**RE: Baylor Drive Property
2635 Baylor Dr. SE
Grading and Drainage Plan
Engineer's Stamp Date: 10/16/20
Hydrology File: M16D044**

**RE: BAYLOR DRIVE PROPERTY
2635 BAYLOR DR. SE
GRADING AND DRAINAGE PLAN
ENGINEER'S STAMP DATE: 08/07/19
HYDROLOGY FILE: M16D044**

GRADING AND DRAINAGE PLAN

- NOTES**
- EXTENDED STEM FOOTING DETAILS WILL BE PROVIDED BY STRUCTURAL ENGINEER
 - PERIMETER RETAINING WALLS ARE TO BE CONSTRUCTED PER RETAINING WALL DETAIL THIS SHEET

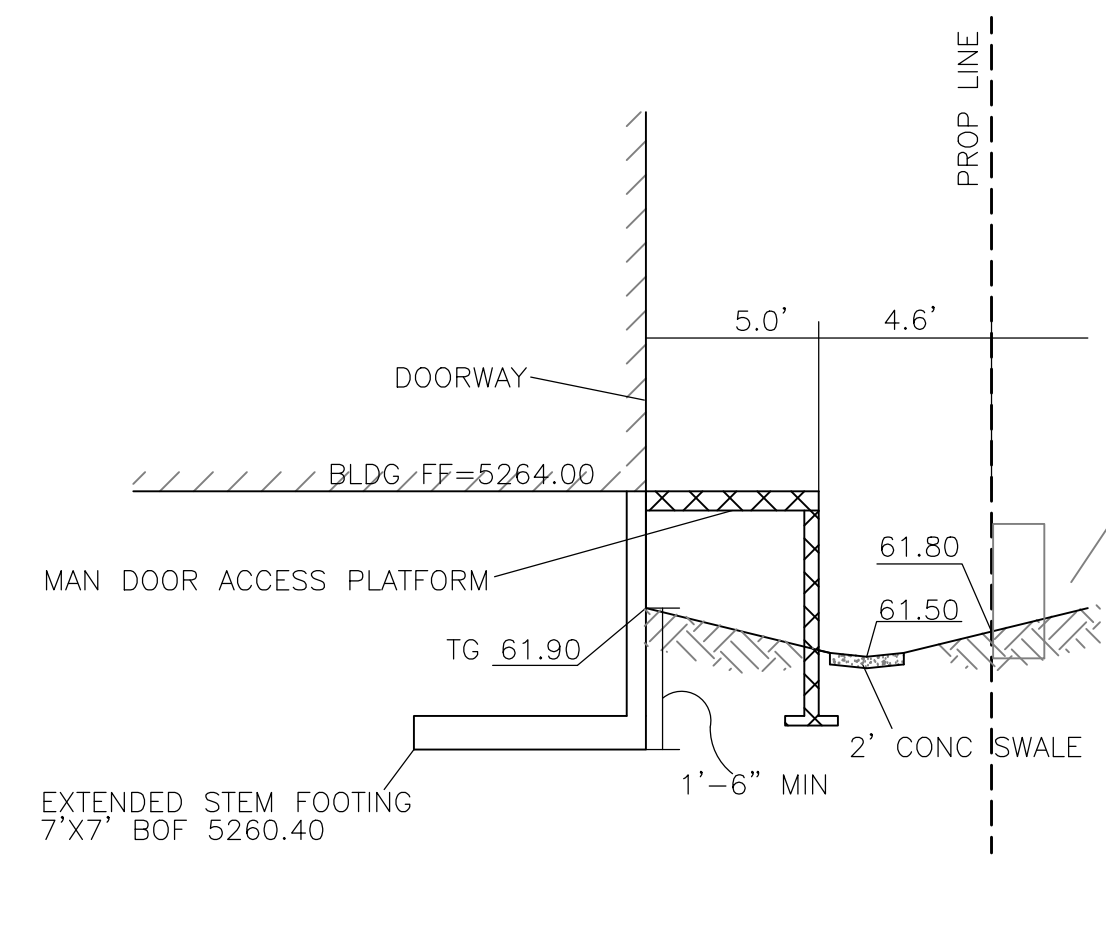
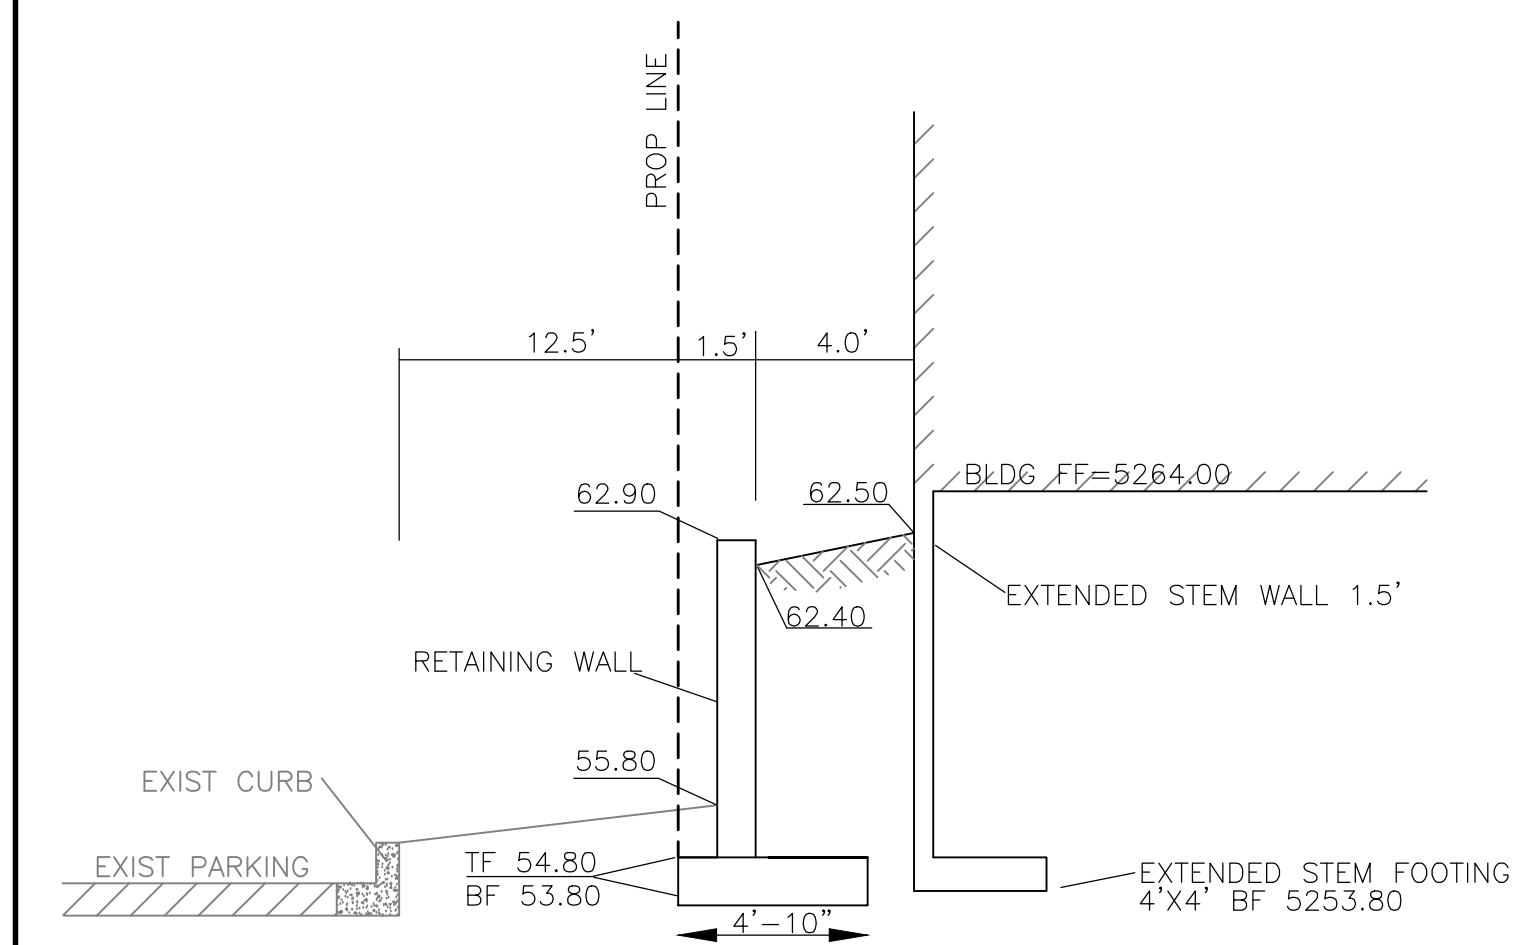
2. Provide sections through all external boundaries showing proposed retaining walls, garden walls, property/ROW lines, existing and proposed grades. In accordance with DPM Ch. 22, section 5 part B, grading and wall construction near the property line may not endanger adjacent property or constrain its use.

4. Please provide a cross section of the proposed retention pond showing dimensions, the bottom elevation, the top of wall, and the water surface elevation of the 100 year 10 day volume.

Response: Sections have been added to GR-2.
3. If the proposed retaining wall will create such an encroachment, written agreement from both landowners must be provided for such work. Written permission must include: signature of the property owner or owners representative, statement that undersigned is the owner or authorized representative, permission to construct the encroachment with a brief description of the encroachment.

Response: A pond section has been added to GR-2.
5. Please provide a detail of the proposed 2 ft concrete channel entering the walled retention pond.
Response: A detail of the concrete channel entering the walled retention pond has been added to GR-2.
